M3 Junction 9 Improvement

Scheme Number: TR010055

8.17 Applicant Response to Examining Authority's Second Written Questions (ExQ2)

22 September 2023

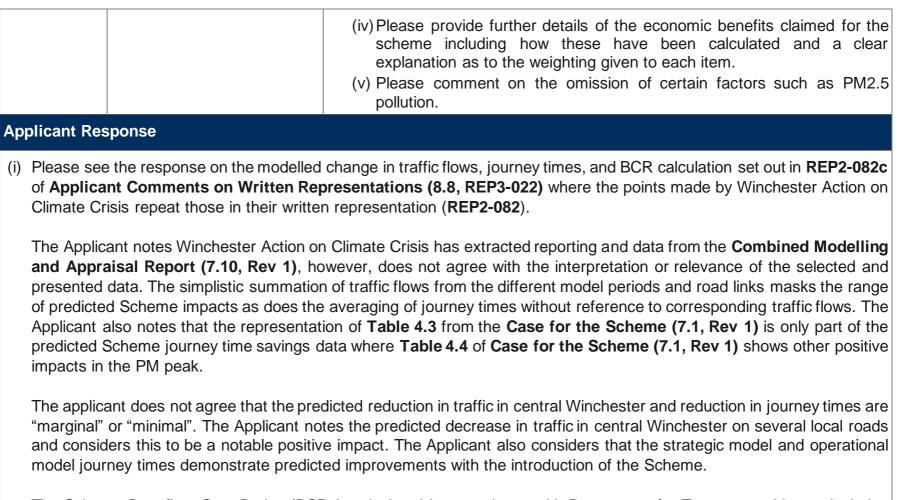
ExQ2	Question to:	Question
Q6.2.12	Assessment	The Climate Emergency Planning and Policy Post Hearing submissions [REP4-042] Section 5.5 deals with the issue of the Tyndall carbon budget for WCC

(i) Please summarise and clarify your position in relation to the relevance of

(ii) Please comment on the value of the carbon emissions from the scheme being assessed in the context of the Tyndall Centre budgets, both for

Tyndall Centre budgets, can be used for contextualisation only and cannot be used to assess the significance of effects. As a nationally significant transport infrastructure scheme, it is not appropriate to assess against local budgets as trips enter from and extend beyond the Winchester City Council and Hampshire boundaries, Any contextualisation against the Tyndall Centre budgets would provide supplementary information only and would not form an alternative assessment to that within **Chapter 14 (Climate)** of the **Environmental Statement (ES) (6.1, Rev 2)**. Given that the Applicant has provided additional contextualisation against the Carbon Budget Delivery Plan (CBDP), provided in **Appendix A** of the **Applicant Comments on Deadline 3 Submissions (8.16, REP4-037)**, the Applicant has not undertaken another contextualisation against the Tyndall Centre budgets, nor is it a requirement to do so in the DMRB LA 114 Climate (National Highways, 2021).
